# Valley of the Winds Wind Farm

## Addendum to Landscape and Visual Impact Assessment

The purpose of this Addendum Report is to provide additional information relevant to the Landscape and Visual Impact Assessment (LVIA) prepared by Moir Landscape Architecture for the Valley of the Winds Wind Farm Project (SSD-10461) referred to hereafter as ‘the Project’.

Since lodging the EIS, ACEN (the Proponent) has made amendments to the 2022 project layout (referred to as the Superseded Layout) in response to matters raised in the submissions and further agency, community and stakeholder consultation. This Addendum Report provides an updated assessment of the revised project layout (referred to as the ‘Revised Layout’).

Figure 1. Project Layout Amendments

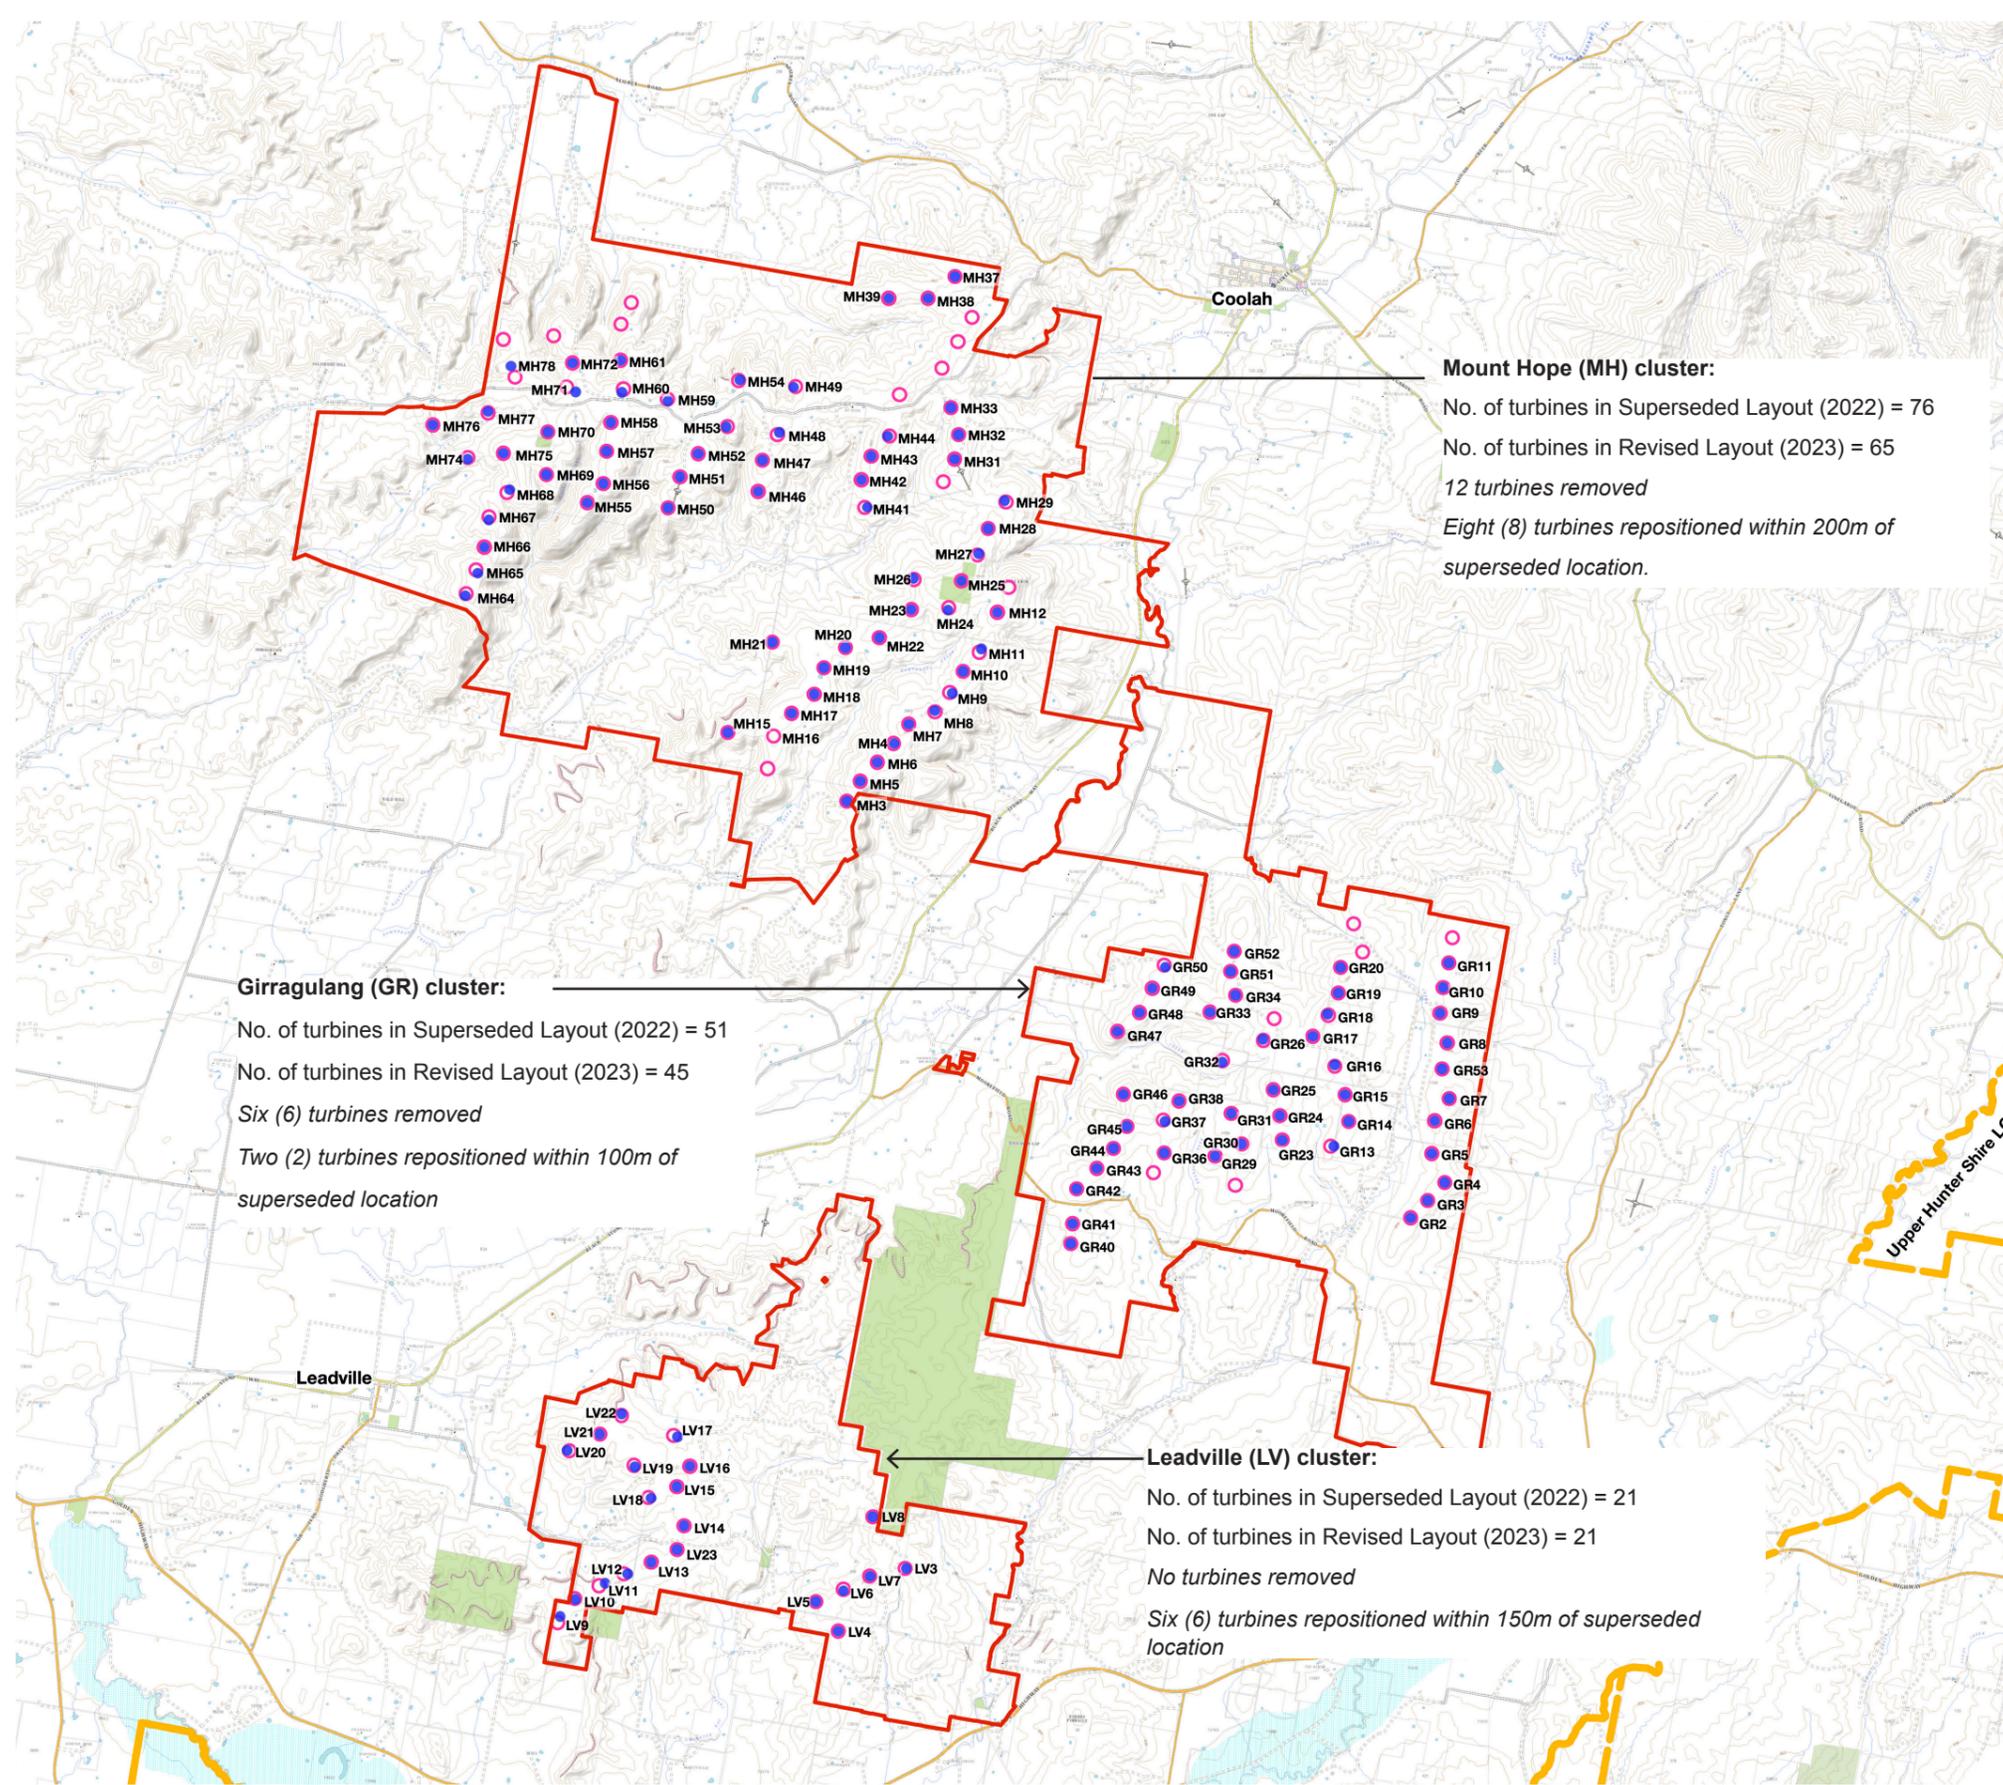
- **Project Layout:**
  - Updated project boundary to remove a property from the Mount Hope cluster.
  - Removal of 17 wind turbines and associated access tracks to reduce amenity impacts for nearby dwellings and biodiversity impacts.

**Mount Hope (MH) cluster:**  
 No. of turbines in Superseded Layout (2022) = 76  
 No. of turbines in Revised Layout (2023) = 65  
 12 turbines removed  
 Eight (8) turbines repositioned within 200m of superseded location.

**Girragulang (GR) cluster:**  
 No. of turbines in Superseded Layout (2022) = 51  
 No. of turbines in Revised Layout (2023) = 45  
 Six (6) turbines removed  
 Two (2) turbines repositioned within 100m of superseded location

**Leadville (LV) cluster:**  
 No. of turbines in Superseded Layout (2022) = 21  
 No. of turbines in Revised Layout (2023) = 21  
 No turbines removed  
 Six (6) turbines repositioned within 150m of superseded location

**Total number of turbines in Superseded 2022 layout = 148**  
**Total number of turbines in Revised 2023 layout = 131**  
**Total number of turbines reduced = 17**

Figure 3. Updated Visual Magnitude Figure (2023)

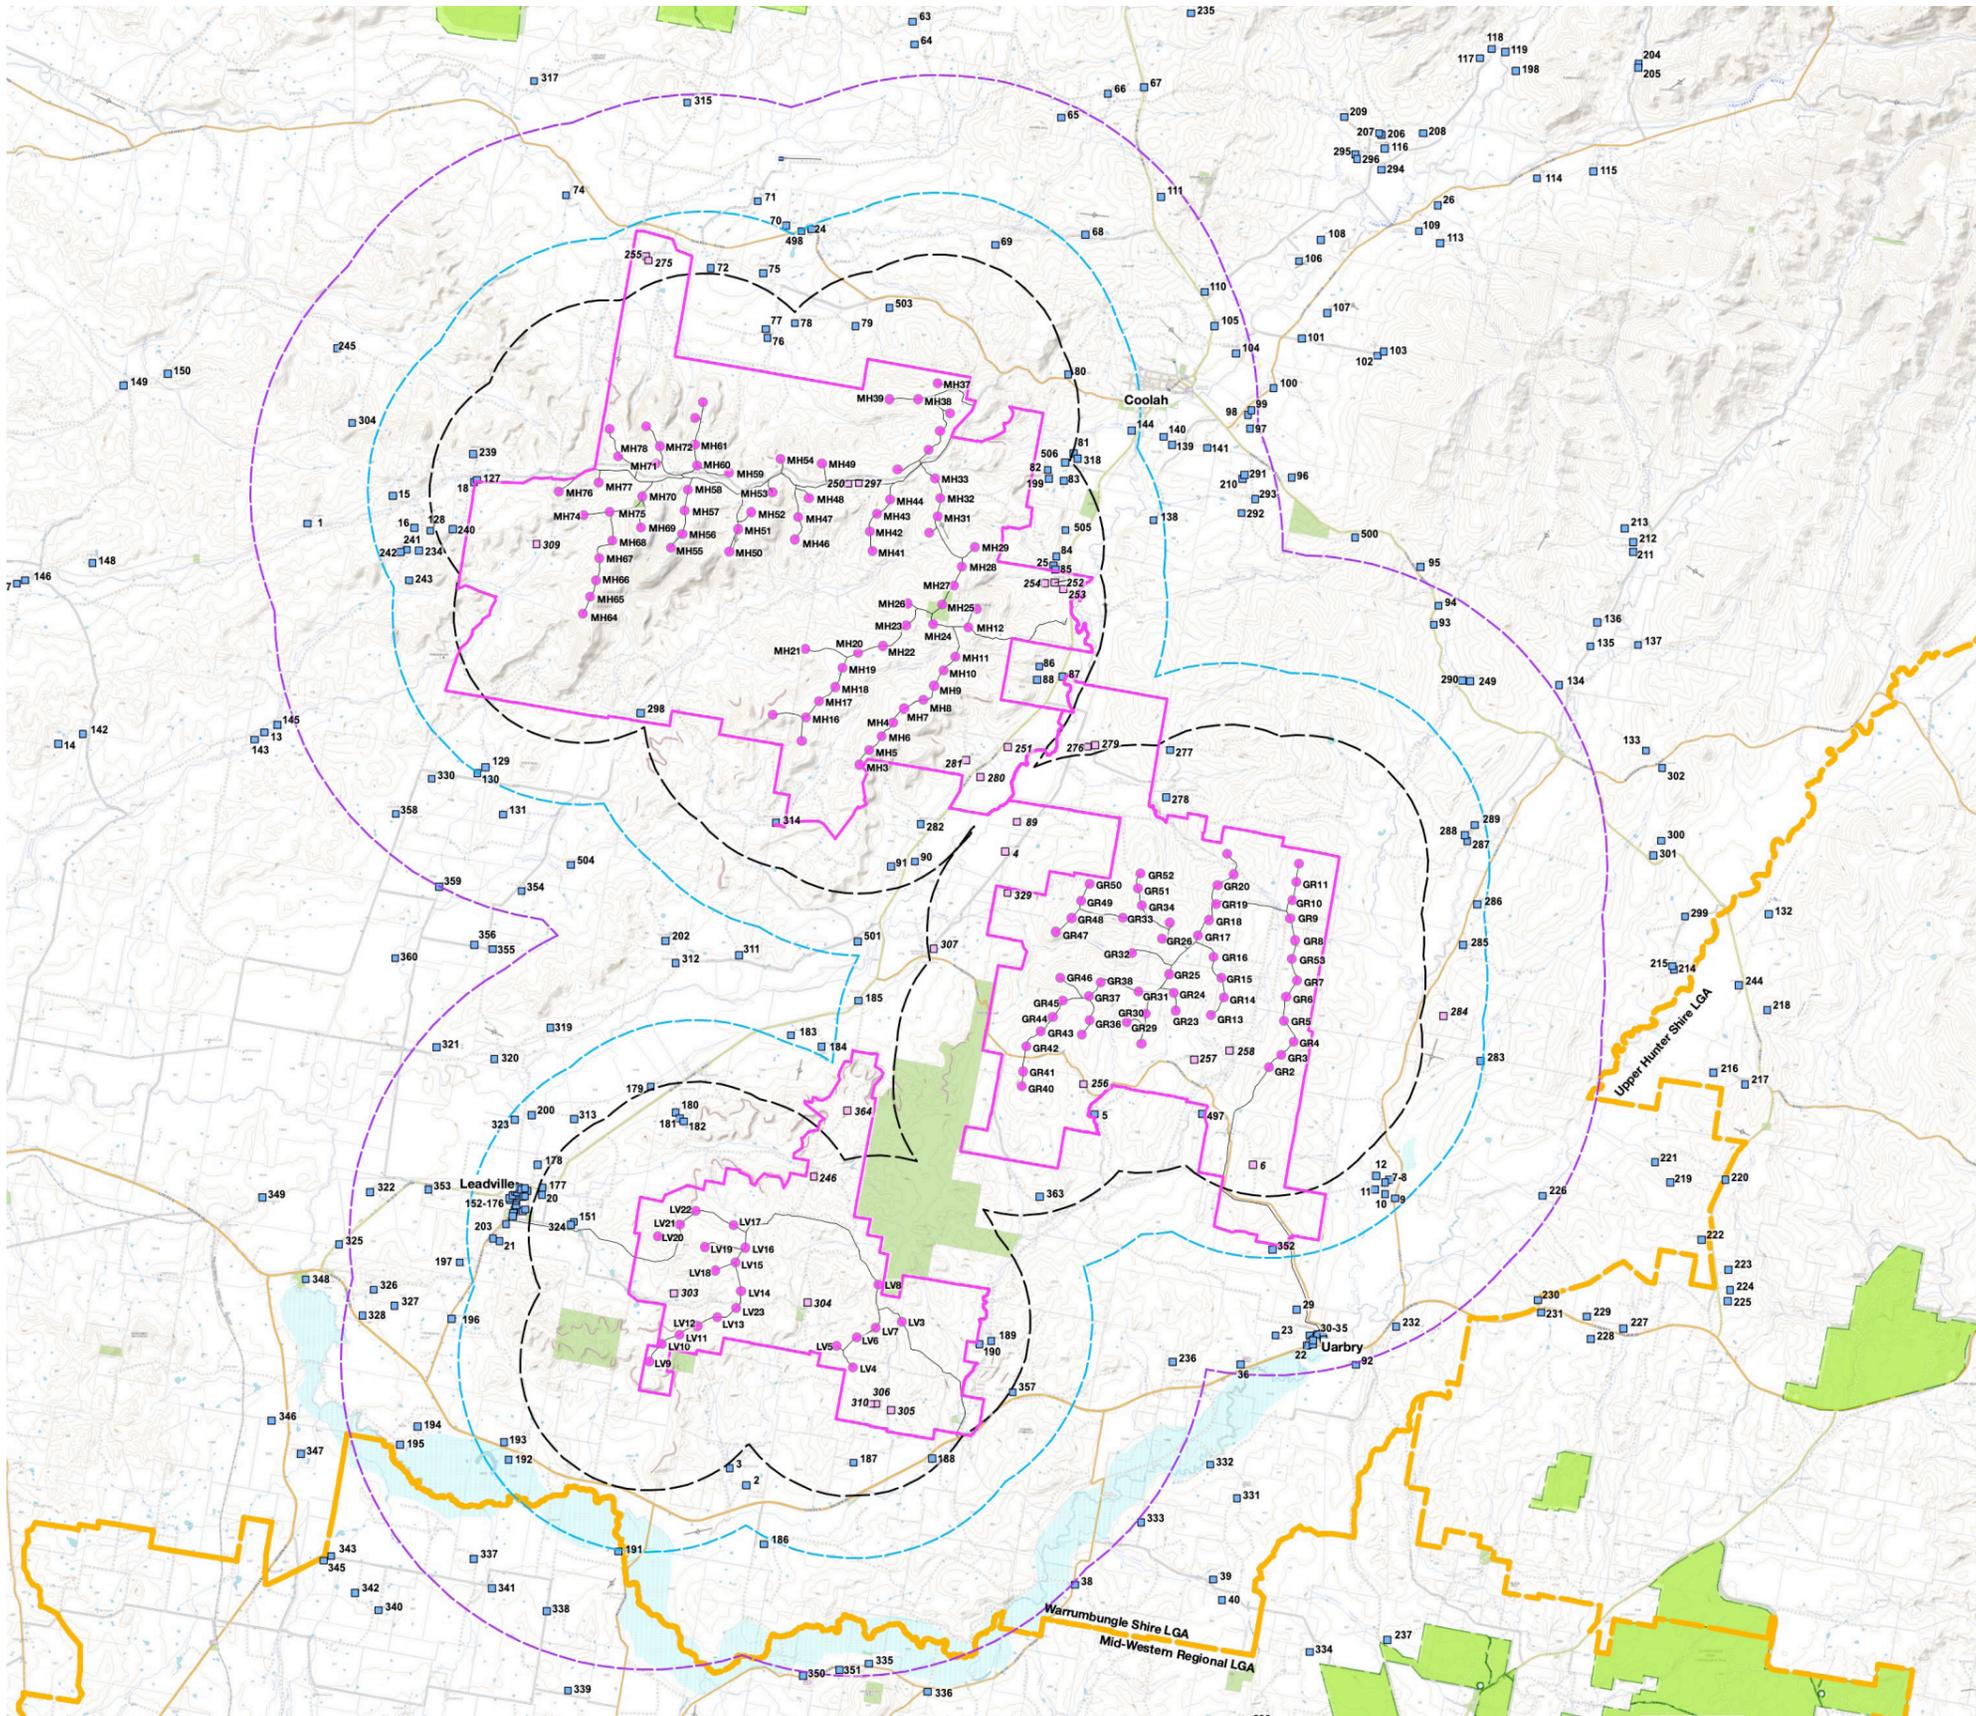
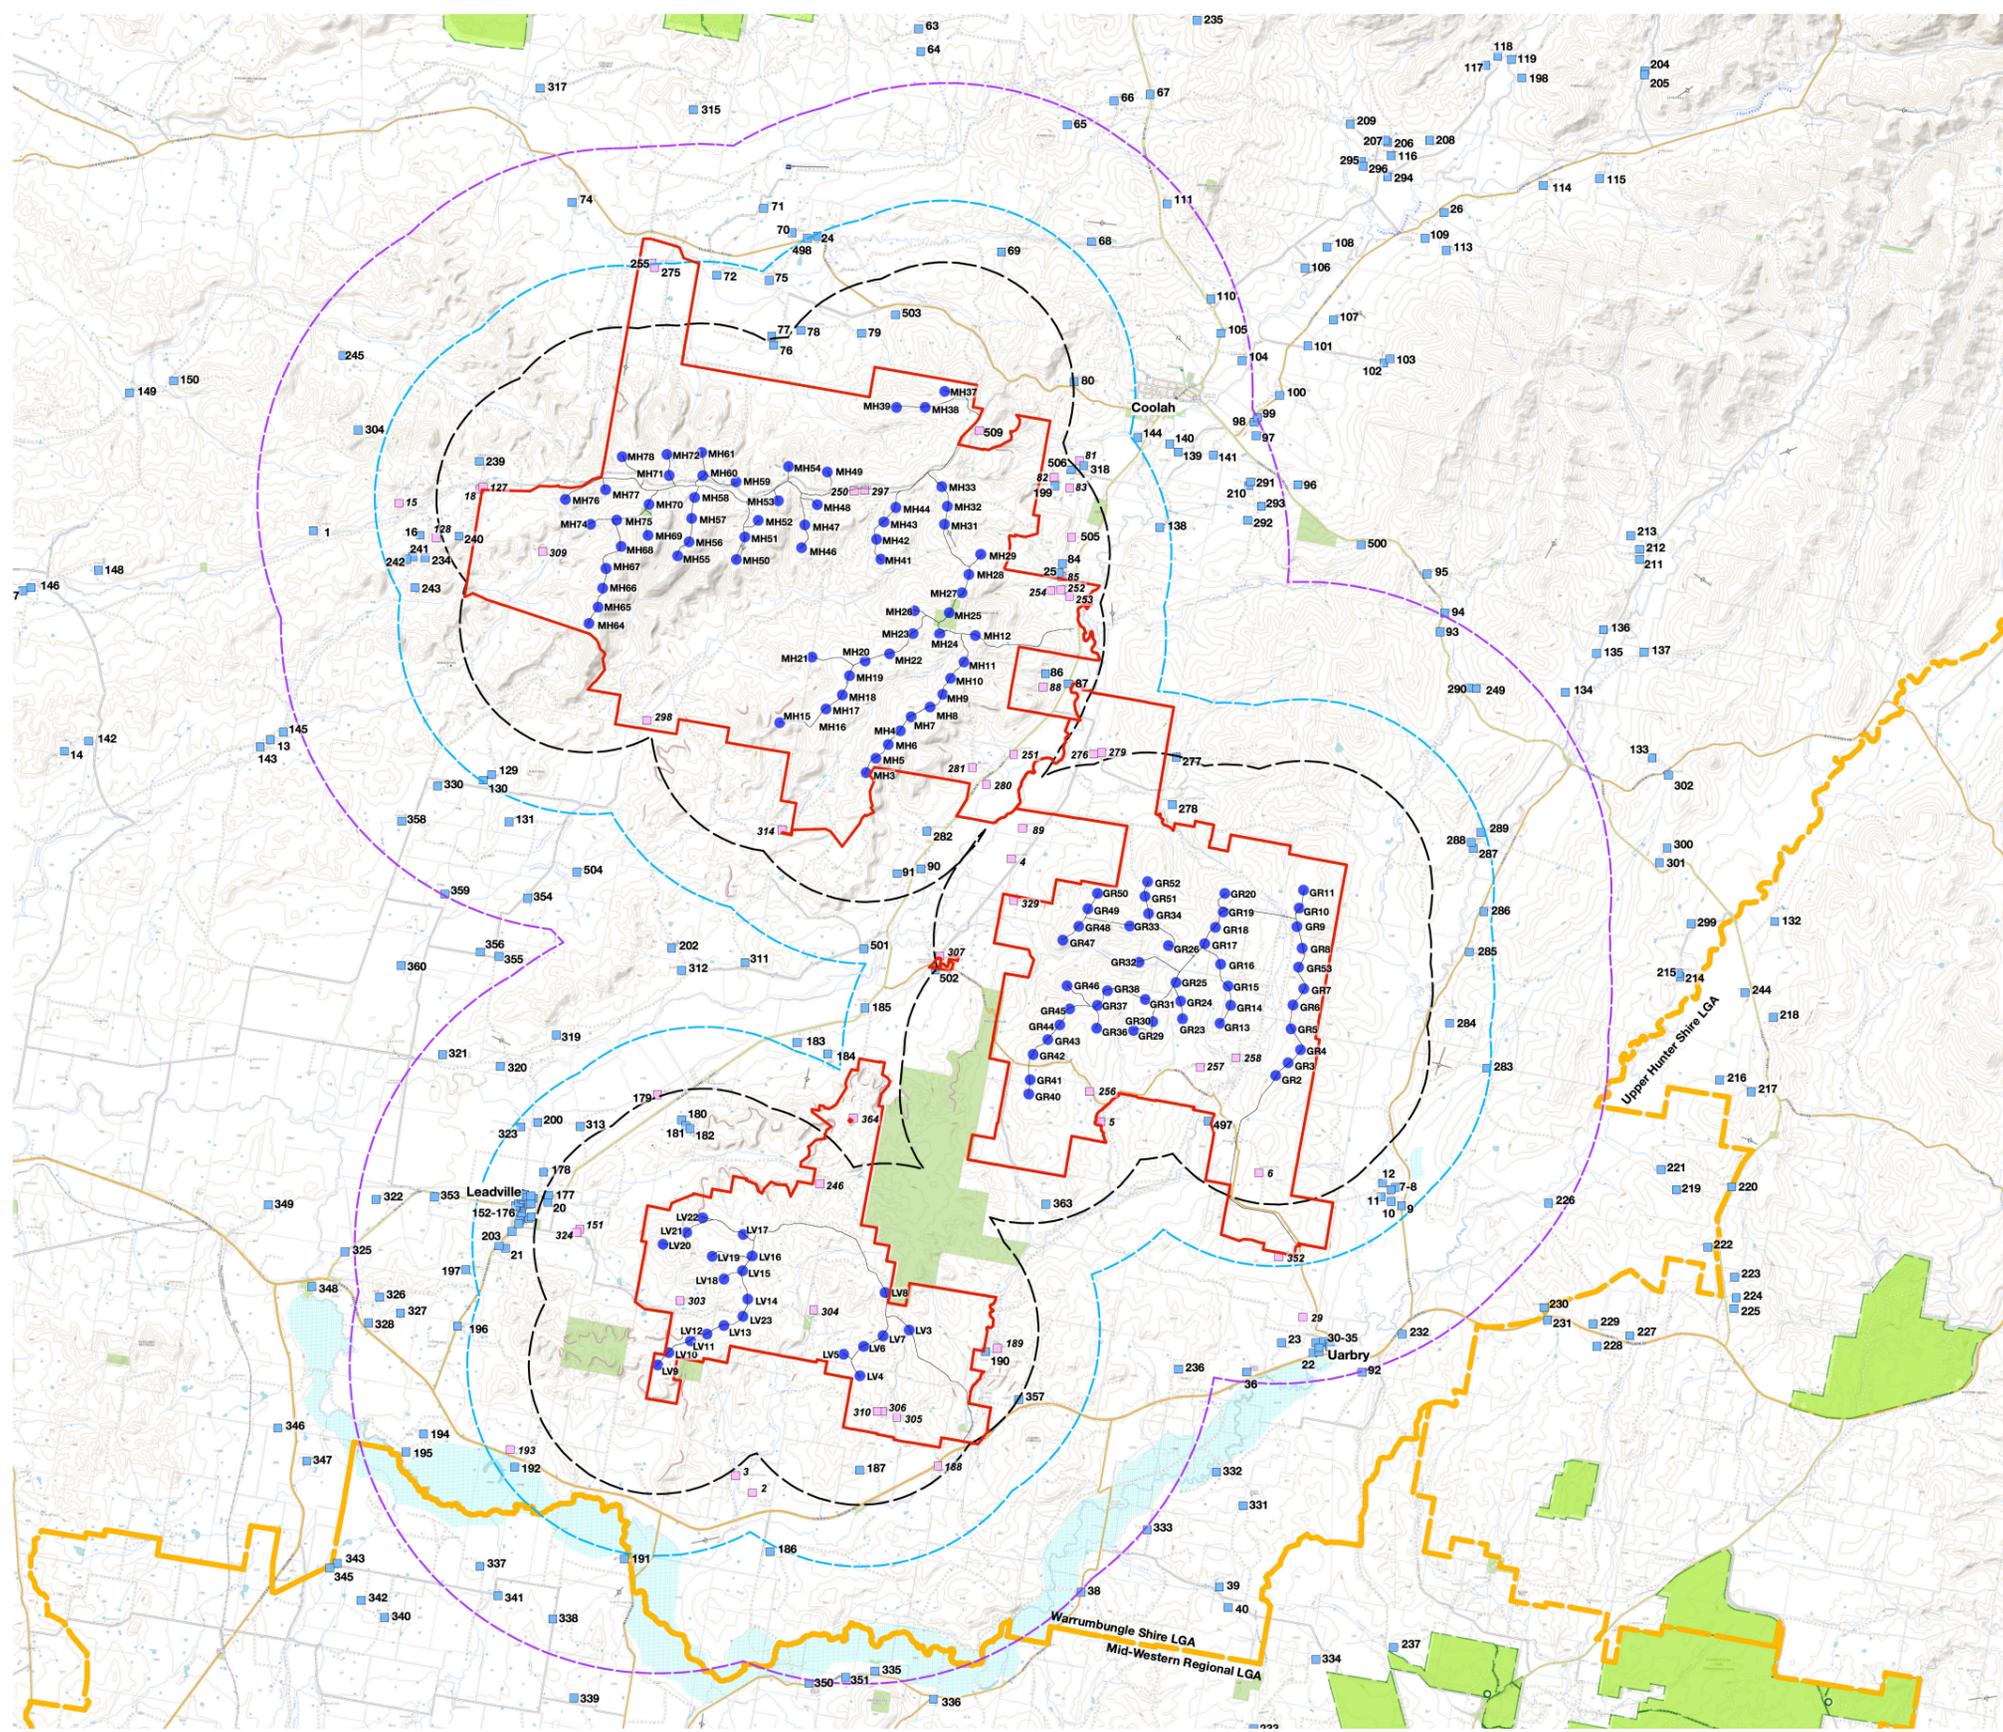
As a result of the amendments to the layout and updates to dwelling status, a total of 91 non-participating dwellings have been identified within 4,950 m of the Revised Layout.

Distance from the nearest turbine:	Superseded Layout (2022):	Revised Layout (2023):	Variation:
<b>Number of non-participating dwellings:</b>			
Within Black Line of Visual Magnitude: 3,350 m	<b>42</b>	<b>27</b>	<b>Reduction of 15 non-participating dwellings</b>
Within Blue Line of Visual Magnitude: 4,950 m	<b>70</b>	<b>64</b>	<b>Reduction of six (6) non-participating dwellings</b>
Total:	<b>112</b>	<b>91</b>	<b>Reduction of 21 non-participating dwellings</b>
